**Update to Urgent Field Safety Notice**  
**Medtronic HeartWare™ HVAD™ System**  
 Power Source Lubricant Servicing

Medtronic reference: FA817 Phase III

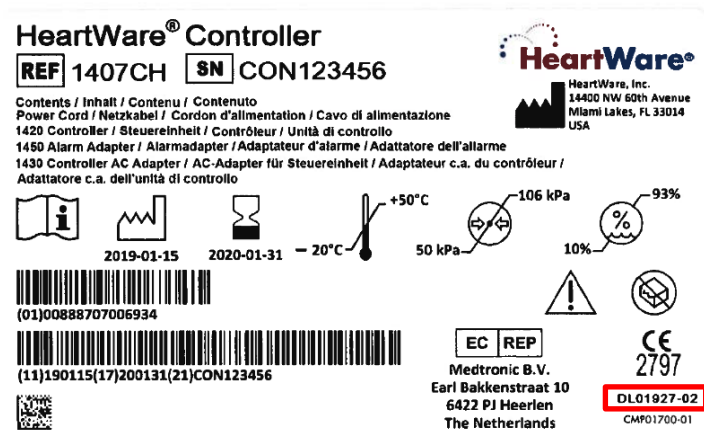
Controller Kits (Models 1400, 1401, 1407) containing an AC Adapter (Model 1425 or 1430) that are lubricated during manufacturing are identified by device label number, DL01927-02, as shown by location of the red box on the packaging label below.
